**Re: SSD-80287510 – Residential development with infill affordable housing,
84 Tallawong Road, Rouse Hill**

Attachment 1

Blacktown Council's submission to SSD-80287510 – Residential development with infill affordable housing, 84 Tallawong Road, Rouse Hill

1. Waste Management Section

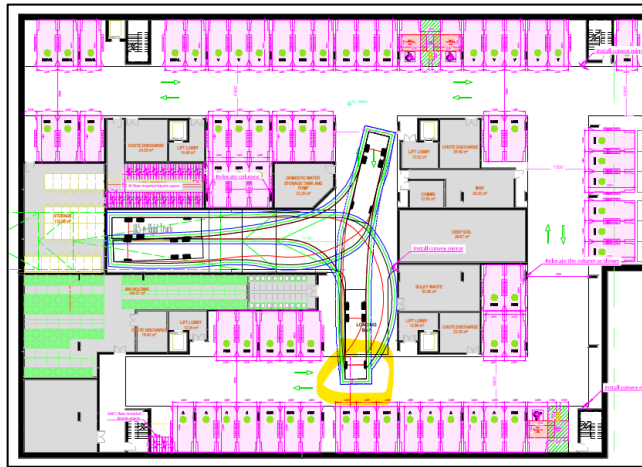
- a) Confirm if the basements are combined for Buildings A and B, C and D, and E and F. This is not clear from the plans or from the waste management plan. Please update the latter with this information.

- b) Confirm that only one loading bay is proposed for the whole site (ie, 411 units).
- c) Add a bulky waste storage area adjacent to the lifts in the basement for Buildings C and D, and E and F.

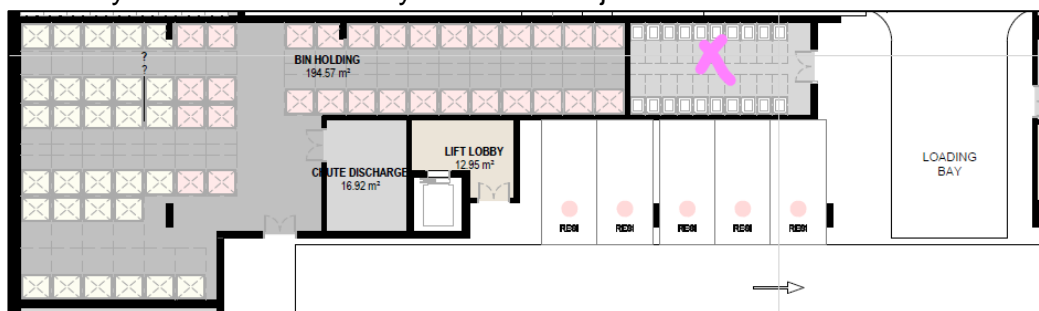
- l) Clarify what the room marked with a pink cross is, if the waste and recycling bins are already indicated in red and yellow in the adjacent room.

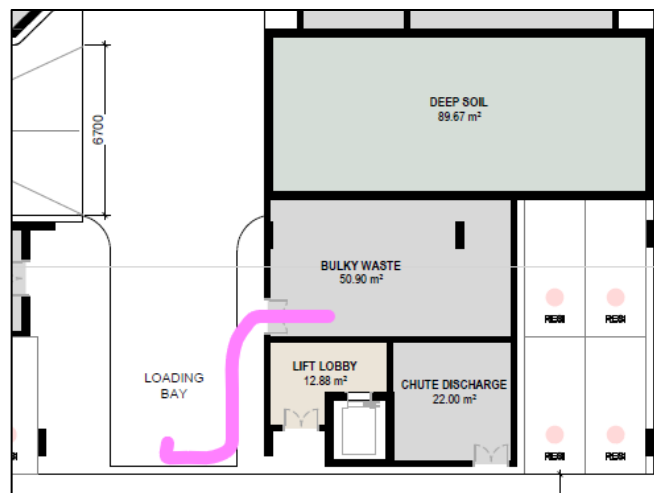
- m) Reconfigure the waste room to a more regular shape so that the bins are closer to the loading bay to reduce manual handling.
